# HISTORIC AND DESIGN REVIEW COMMISSION

April 07, 2021

**HDRC CASE NO:** 2020-433  
**ADDRESS:** 326 RIVERSIDE DR  
**LEGAL DESCRIPTION:** NCB 7672 BLK 21 LOT NW 170 X 15 OF 5, N IRR 190 OF 6, N 207.86 OF 7, N 207.86 OF E 102 OF 8  
**ZONING:** IDZ-1, RIO-5, H  
**CITY COUNCIL DIST.:** 3  
**DISTRICT:** Mission Historic District  
**APPLICANT:** Nicholas Melde/Architexas  
**OWNER:** Peter Greenblum/326 RIVERSIDE LLC  
**TYPE OF WORK:** Construction of twenty-five, 2-story residential structures  
**APPLICATION RECEIVED:** March 19, 2021  
**60-DAY REVIEW:** Not applicable due to City Council Emergency Orders  
**CASE MANAGER:** Edward Hall  
**REQUEST:**

The applicant is requesting a Certificate of Appropriateness for approval to construct twenty-five (25), 2-story, single-family residential structures on the lot at 326 Riverside. The two historic structures on the western side of the property will be rehabilitated and are not part of this application.

DEVELOPMENT SITE PLAN

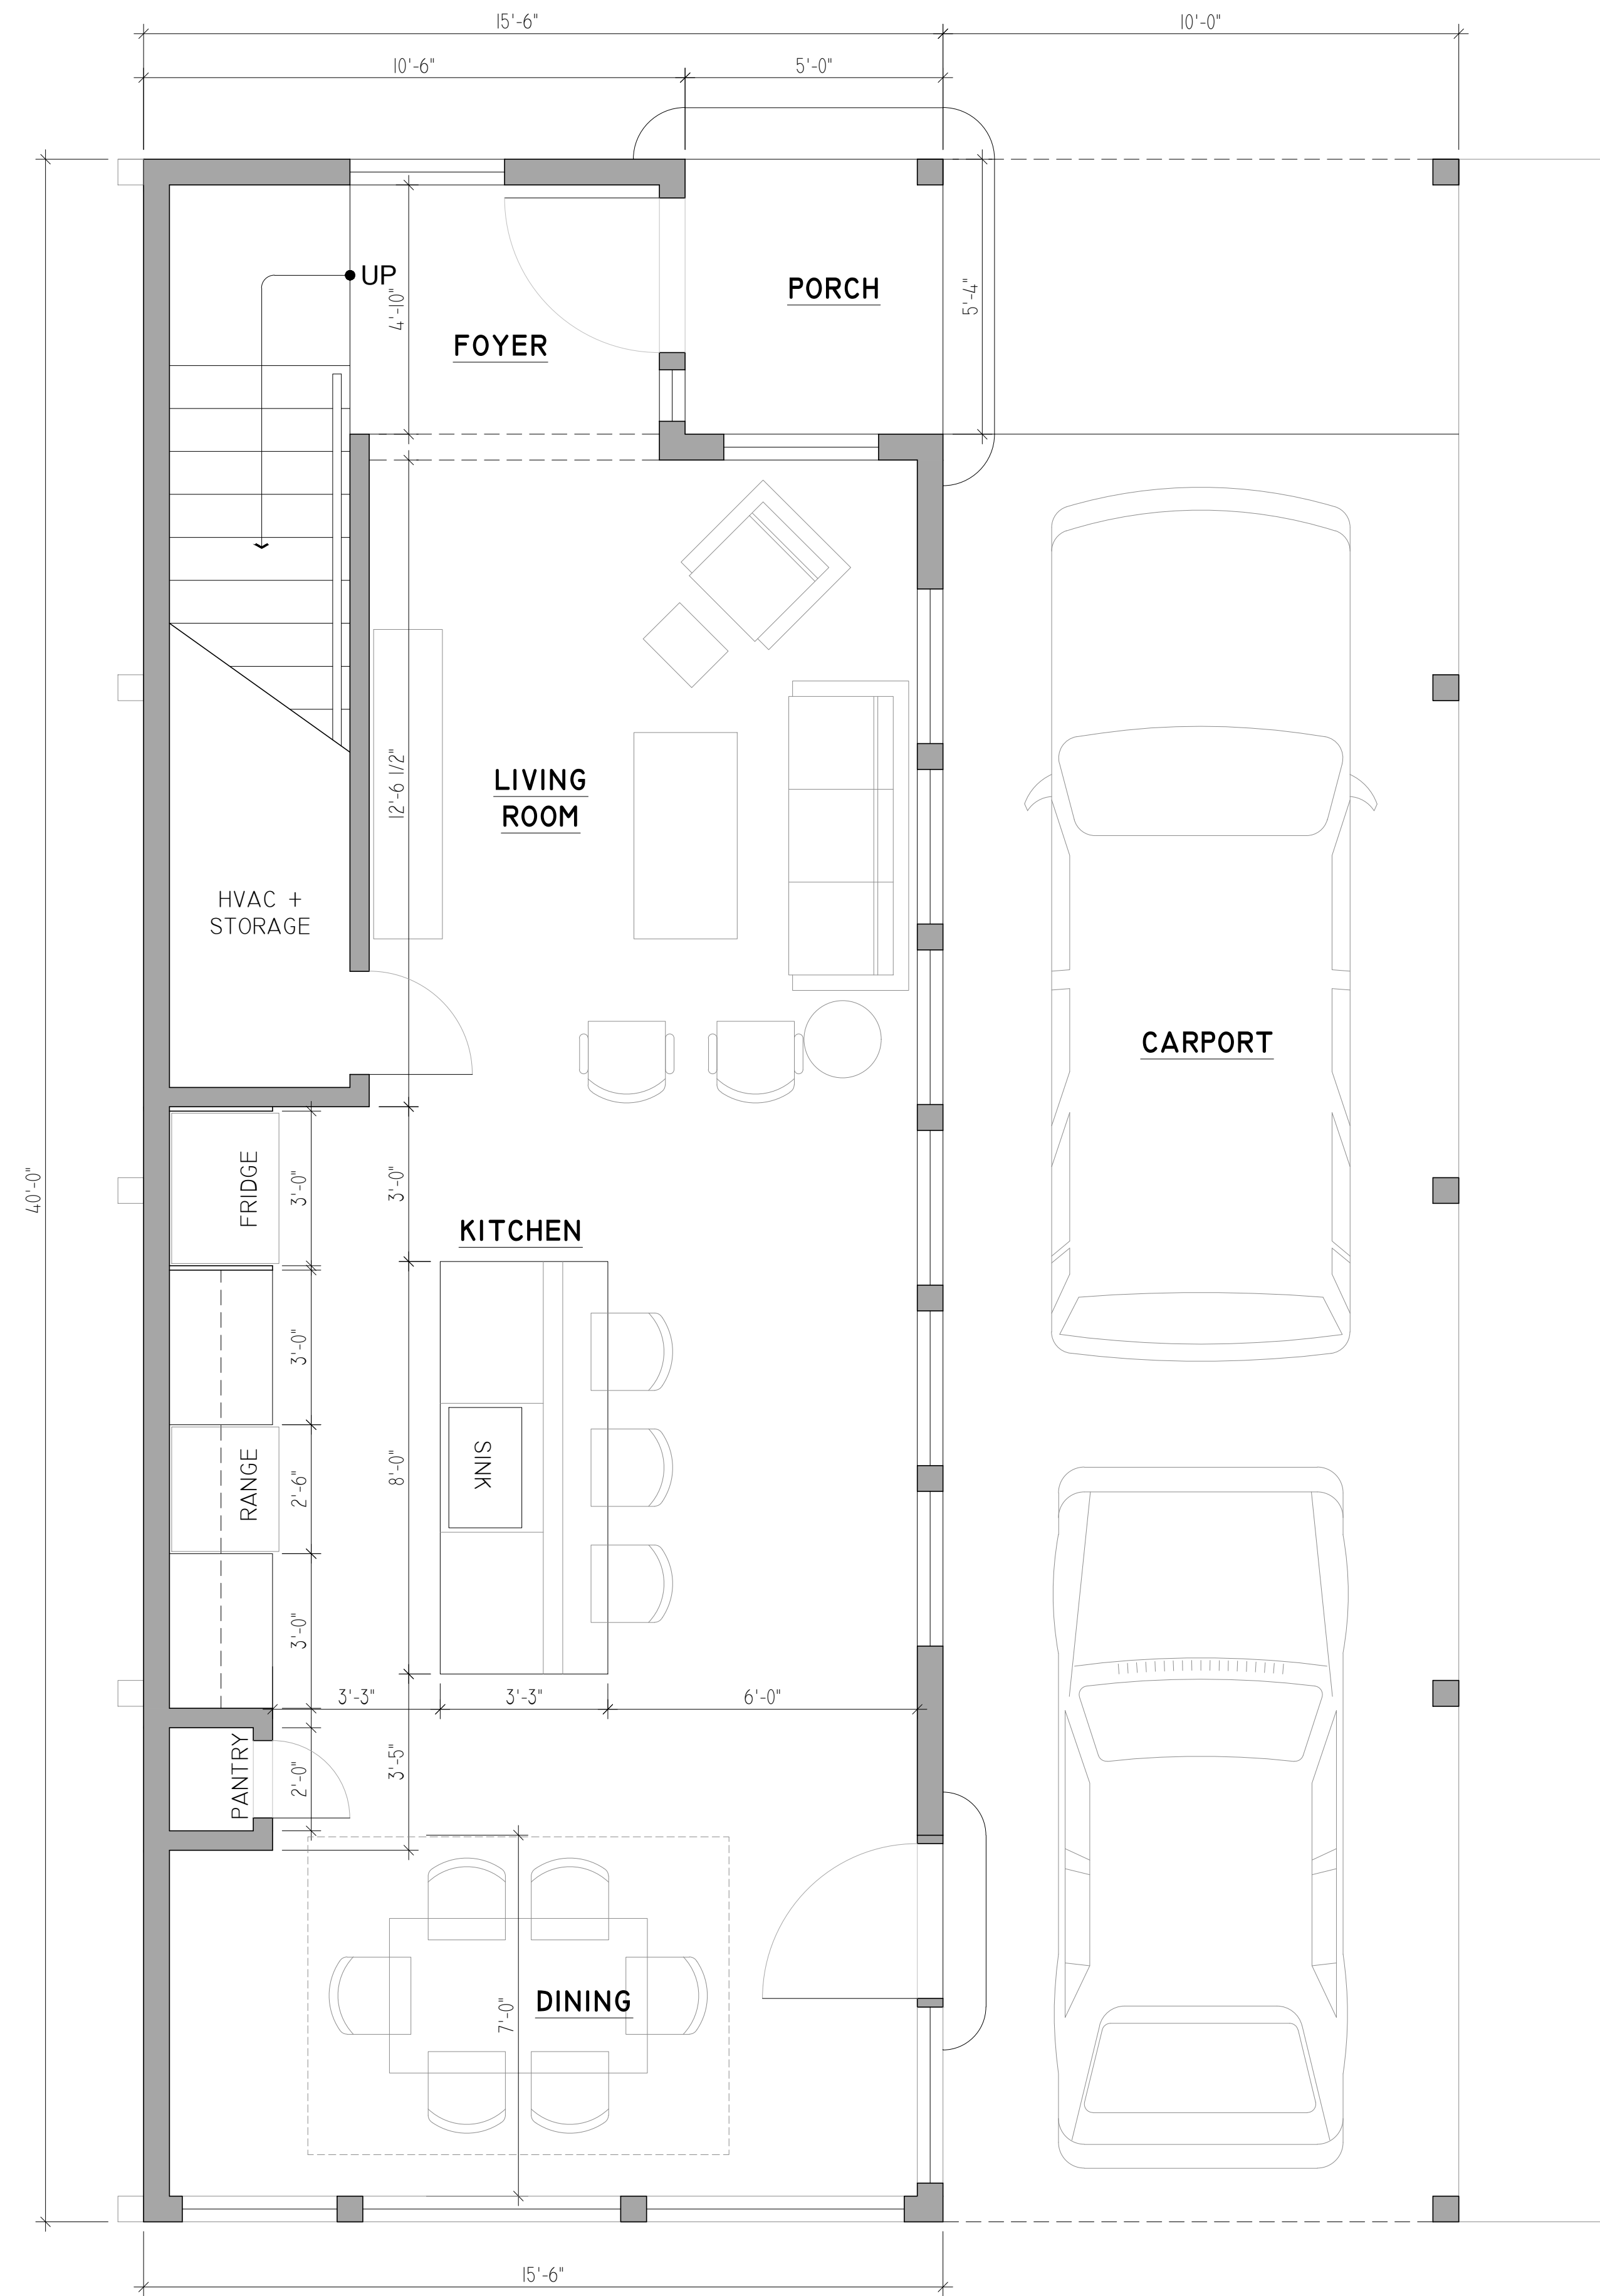
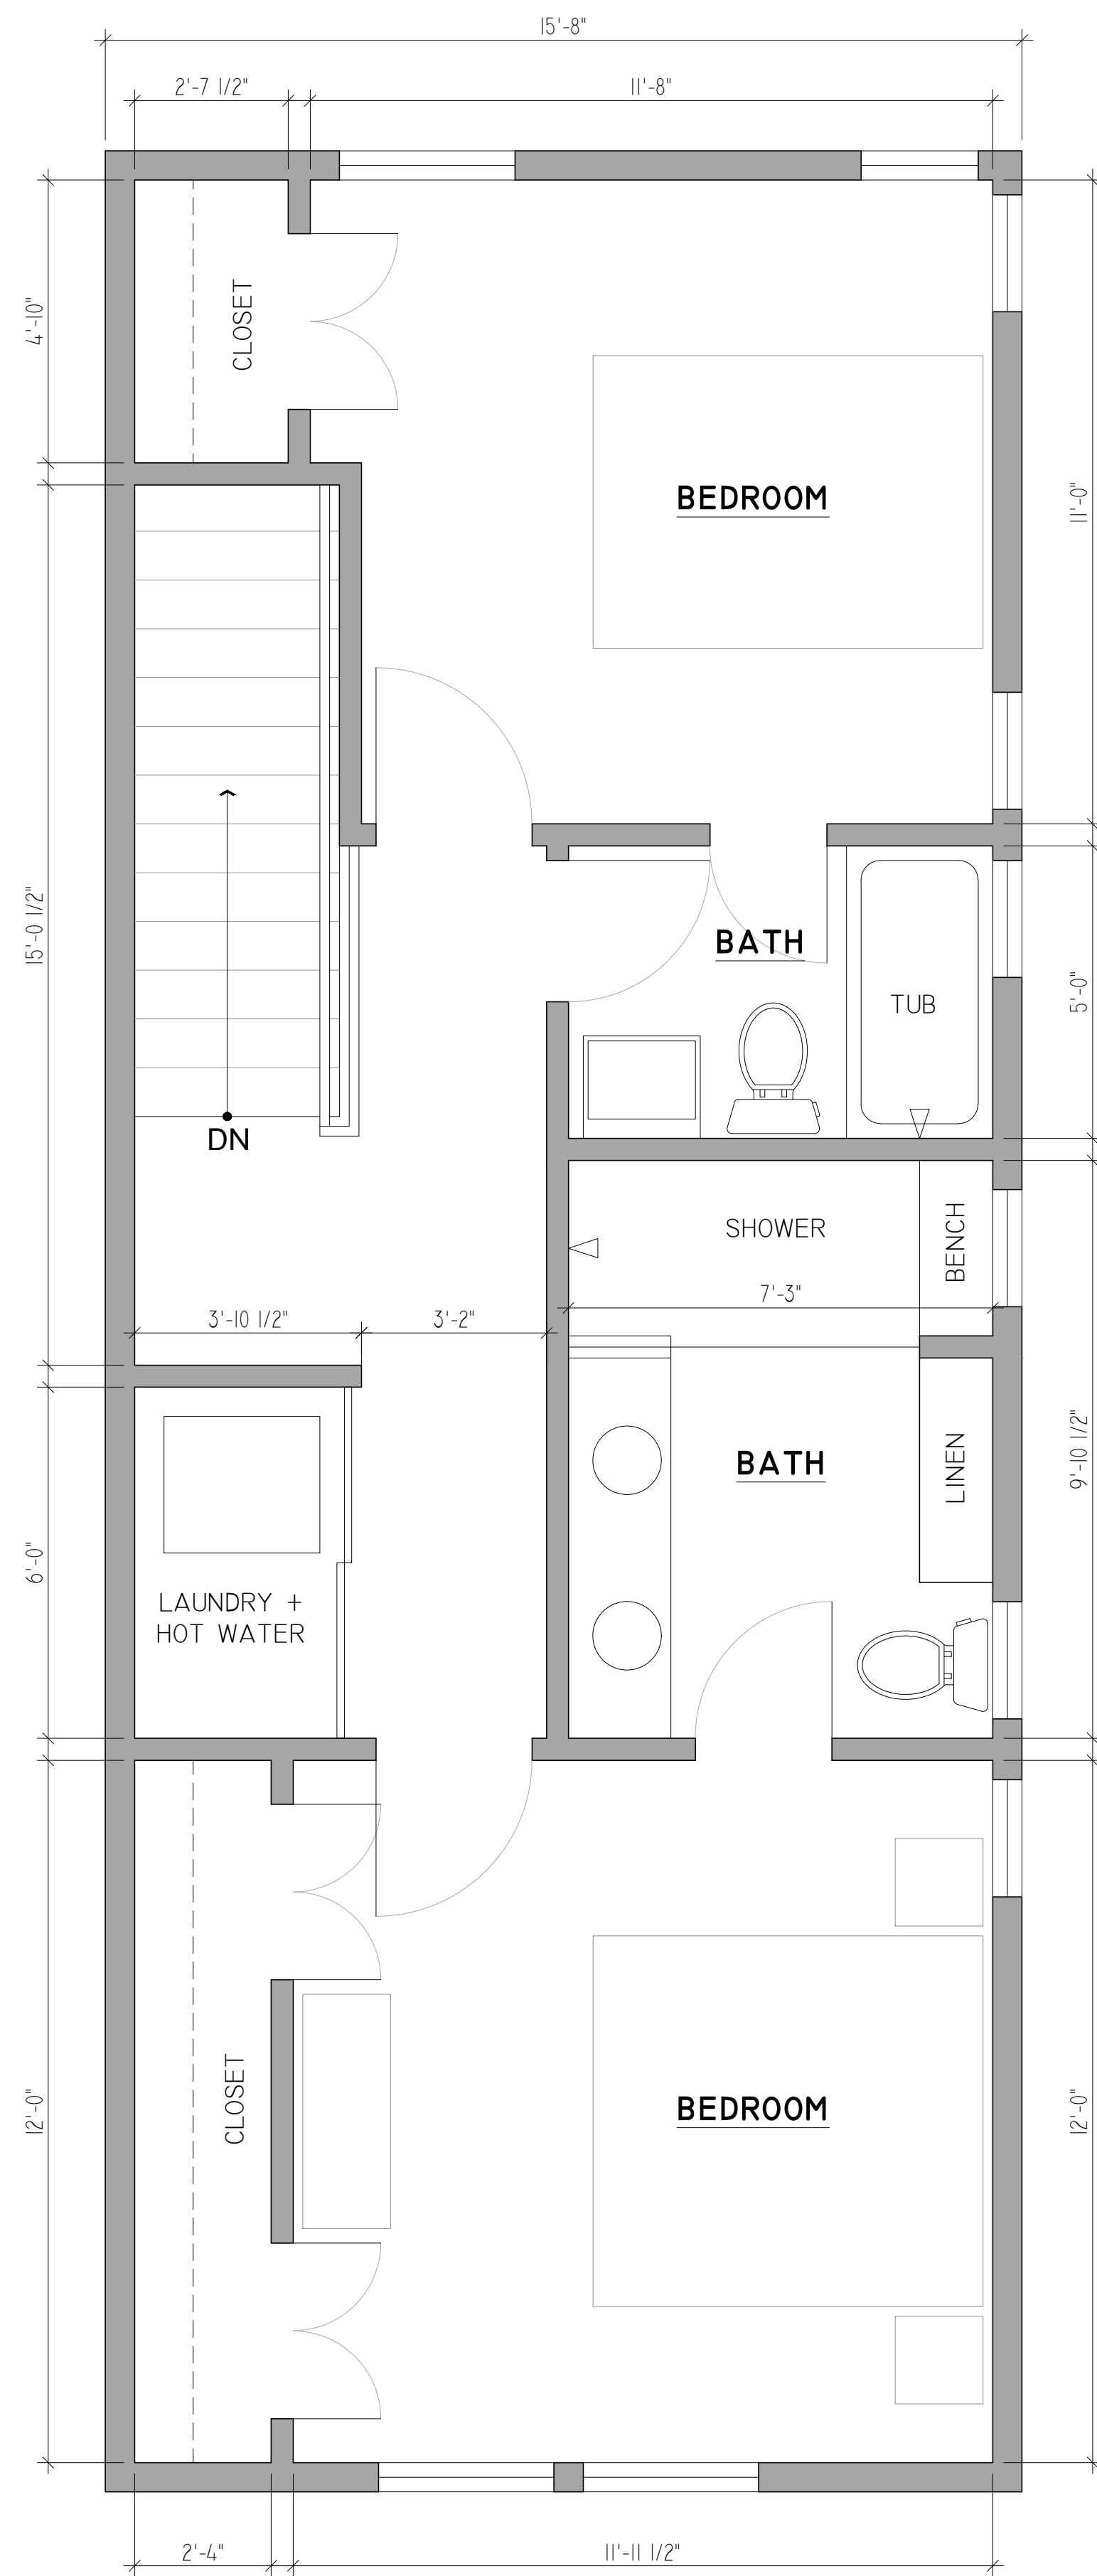
JF: A landscaping plan should be included (trees, common space, etc.)

AMG: Provide numbers for pervious/impervious lot coverage.

AG: Questions regarding footprint/square footage of each unit (approx. 1,200 to 1,300 sq ft).

- a. That a detailed landscaping plan be developed, and that walkways align with front porches.
- b. That the applicant coordinate with the San Antonio River Authority in regards to regarding direct access to the San Antonio River, landscaping and maintenance boundaries and storm water control measures prior to the submission for a Certificate of Appropriateness.
